**Comment Response Document**  
**Regarding the Total Maximum Daily Load of Polychlorinated Biphenyls in South River**  
**Mesohaline Chesapeake Bay Segment, Anne Arundel County, Maryland**

The Maryland Department of the Environment (MDE) has conducted a public review of the proposed Total Maximum Daily Load (TMDL) of Polychlorinated Biphenyls (PCBs) in the South River Watershed. The public comment period was open from July 17, 2014 through August 15, 2014. MDE received three sets of written comments from the South River Federation (Capt. Diana Muller, et.al.), Mr. Christopher Phipps, P.E. of Anne Arundel County, Dept. of Public Works, and a number of very similar letters and comments from Ms. Gwenn Azama, Ms. Kinsey Potter, Ms. Beverly Marcus and Mr. John Koontz.

**Figure 1: MDE tPCB and Stations in South River, MD (Provided by Commentors)**

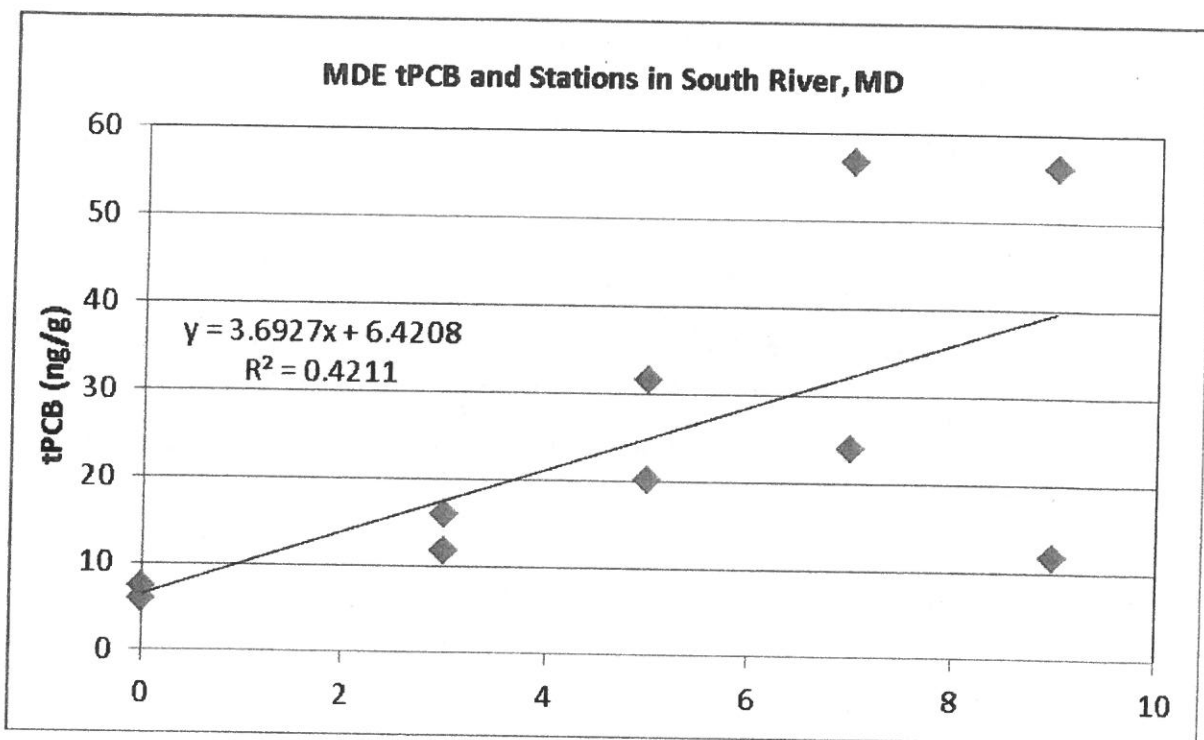
The Commentor asserts that the tPCB water column data shows that the tPCB concentrations are higher in the South River than in the Chesapeake Bay mainstem. “...The Chesapeake Bay mainstem tidal influence and resuspension and diffusion from the bottom sediments are the two primary sources of tPCB baseline loads resulting in the PCB impairment in the South River embayment. MDE’s own sediment tPCB data shows an increase with tPCB concentration as going from Bay into River- meaning the concentrations at Stations STH5 are higher than the Chesapeake Bay ( $r^2 = 0.42$ )- stations are plotted over distance (See Figure 1). This is consistent with the Muller and Muller, 2014 paper where results show that it is the South River polluting the Bay and not the Bay polluting the South River. Either the data was entered into the MDE model incorrectly or they completely study was flawed. MDE’s own data is counter to what they are stating in their comments.

MDE disagrees with the commenter's conclusion that the data and results presented in this TMDL report show that sources from within the South River watershed are polluting the Chesapeake Bay with PCBs. While the Muller study provides a detailed analysis of monitoring data for temperature, dissolved oxygen, pH, water clarity and nutrients, it does not present any PCB data. MDE believes that the conclusions from this paper cannot be broadly applied to PCBs. The following response will detail three separate analyses that substantiate this statement.

The figure provided in Comment 6, shows PCB concentrations in the bottom sediments of the South River. Because of the complexity of environmental processes involved in the transport and deposition of PCBs sorbed to sediment in tidal waters, it is difficult to use these spatial trends to draw any reliable conclusion about the current sources of PCBs to the embayment.
